Work Order ID 98468

Item Name: Replacement Skidtube

DESIGN	A	DART AEROSPACE LTD HAWKESBURY, ONTARIO, CANADA DRAWING NO. D2580 TITLE 205 SKIDTUBE ASSEMBLY COPYRIGHT © 1996 BY DART AEROSPACE LTD THIS DOCUMENT IS PRIVATE AND NOT TO BE LOANED FOR THE SERVICES CONTRACTOR. IT IS NOT TO BE USED FOR ANY PURPOSE OR COPIED OR COMMUNICATED TO ANY OTHER PERSON WITHOUT THE WRITTEN PERMISSION OF DART AEROSPACE LTD.	REV. E
DRAWN	RF		SHEET 2 OF 2
CHECKED	W		
MFG. APPR.	N		
APPROVED	W		
DE APPR.	W		
DATE	11.06.21		SCALE NT

DRAWING NO. D2580	TITLE 205 SKIDTUBE ASSEMBLY	REV. E	DART AEROSPACE LTD ENGINEERING ORDER	D.E.O. NO. D2580-E-1	SHEET NO. SHEET 1 OF 1	SCALE NTS
DRAWN <i>UP</i>	CHECKED <i>ASS</i>	MFG. APPR. <i>ER</i>	APPROVED <i>#</i>	DE APPR. <i>HA</i>		
DATE 11.12.13	DATE 11.12.13	DATE 11.12.13	DATE 11.12.13	DATE 11.12.13

D5-2
SECTION B-B
SCALE 5X

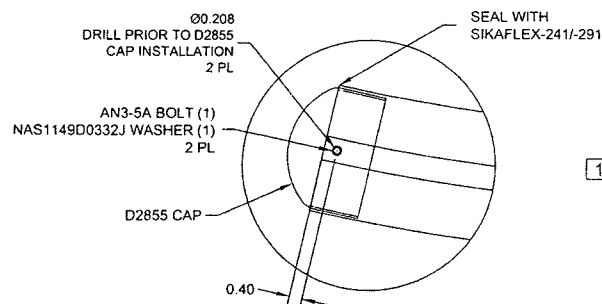
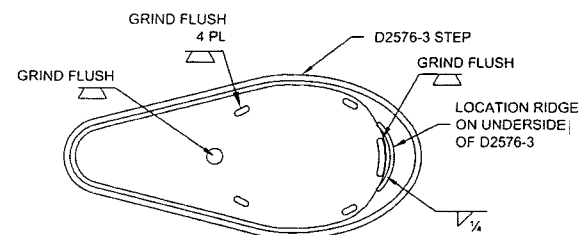
SECTION B-B, SECTION F-F, & SECTION I-I ARE AMENDED AS FOLLOWS
FOR ALL HOLES THAT WERE ORIGINALLY C'BORED:

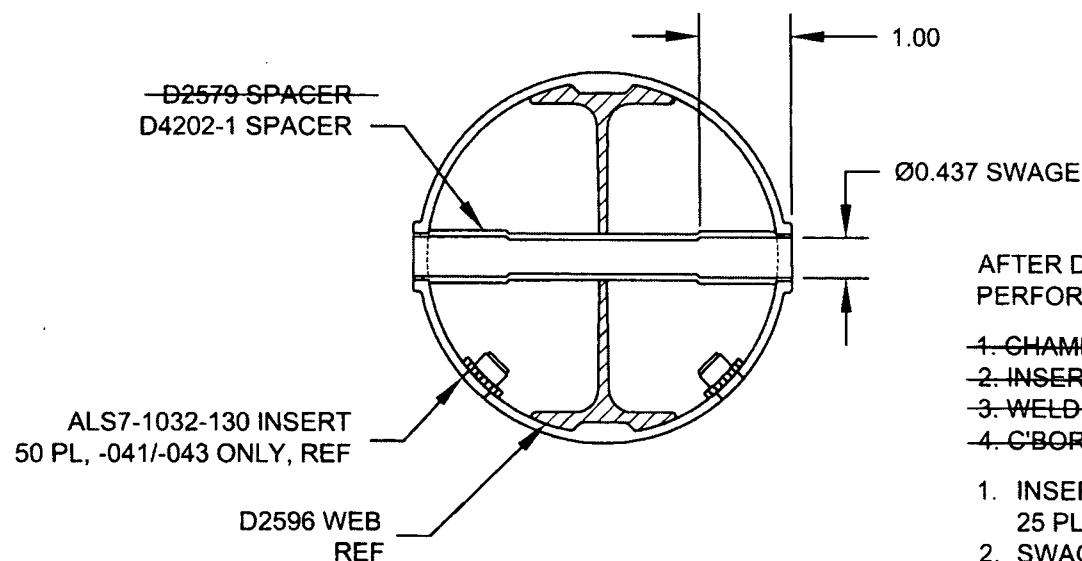
CHANGE ALL C'BORED WELDED CROSSBOLT SPACERS TO SWAGED SPACERS

4		* D2579	CROSS BOLT SPACER
20	20	25	D4202-1	SPACER

*** FOR -045 SKIDTUBE ONLY:**

WELD 4X D2579 SPACERS PER DWG
IN LOCATIONS MARKED "NO C'BORE".
REF SHEET 4 OF DWG.
